**ITB #23-015  
Cemetery Road WWTP Ponds  
Expansion**

**Addendum #4  
Revised Site Plan**

# CONSTRUCTION PLAN FOR: THE CITY OF SEBRING CEMETERY ROAD WWTP POND ADDITIONS

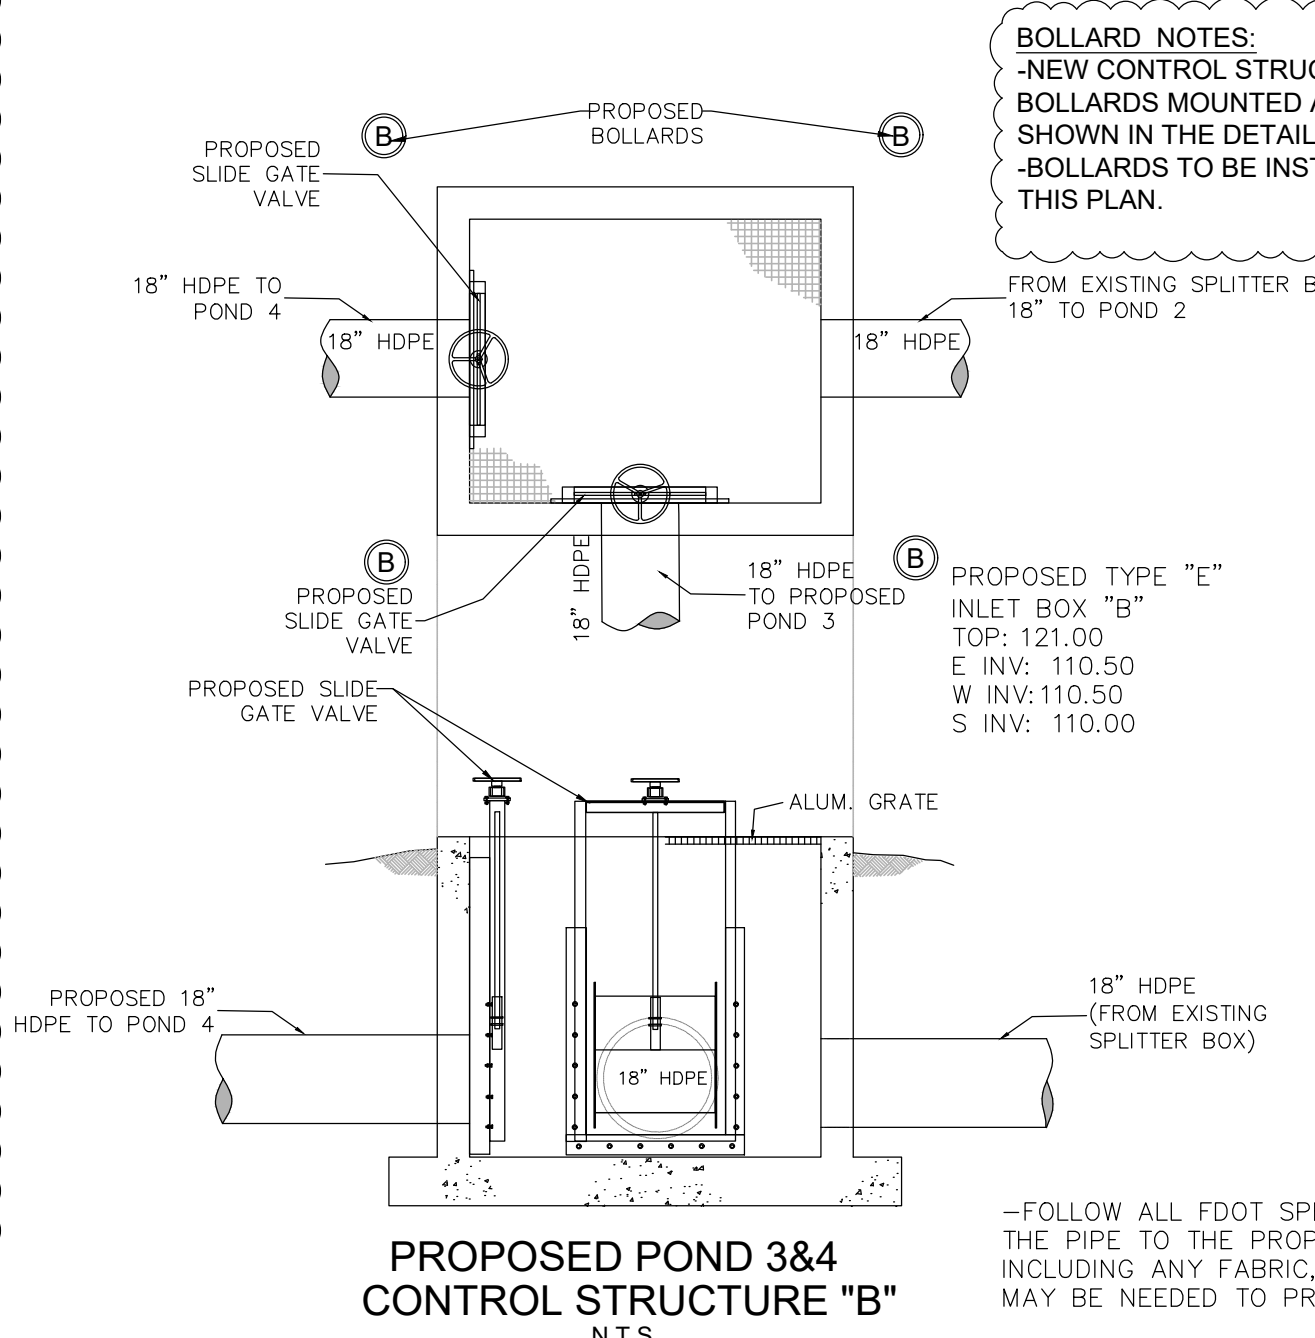
Please see attached (revised) site plan. The city changed the plan to take off the branded product that was used as an example on the information key on pages 27-30 of this original solicitation. Please refer to the updated plan which has the examples removed.

**GATE VALVE ADDENDUM:**  
-NO CHANGES TO THE SPEC OR TYPE OF GATE VALVE AS PART OF THIS ADDENDUM.  
-THE CONTRACTOR MAY SUPPLY ANY BRAND OR MODEL GATE VALVE THAT MEETS THE REQUIREMENTS IN THIS SPECIFICATION.  
-FOLLOW VALVE VENDOR'S SPECIFICATIONS AND DIRECTIONS FOR INSTALLATION.

**GENERAL SPEC:**  
GATE VALVE OPENING HEIGHT: 20-24" (MINIMUM)  
GATE VALVE OPENING WIDTH: 20" (MINIMUM)

**GATE VALVE NOTES:**  
-EXAMPLE GATE VALVE SPEC. SHOWN.  
-MATERIAL NEEDS TO MATCH AS ALUMINUM OR STAINLESS TO PREVENT CORROSION.  
-GATE VALVE NEEDS TO BE ADJUSTABLE AND ABLE TO BE FULLY OPEN AND CLOSED AND INFINITELY IN BETWEEN FOR OPERATOR ADJUSTMENT.  
-ALTERNATE GATE VALVES MUST FOLLOW THE SAME GENERAL SPECIFICATION AND OPERATION.  
-WHEN CLOSED, THE GATE VALVE NEEDS TO STOP >99% OF THE FLOW.
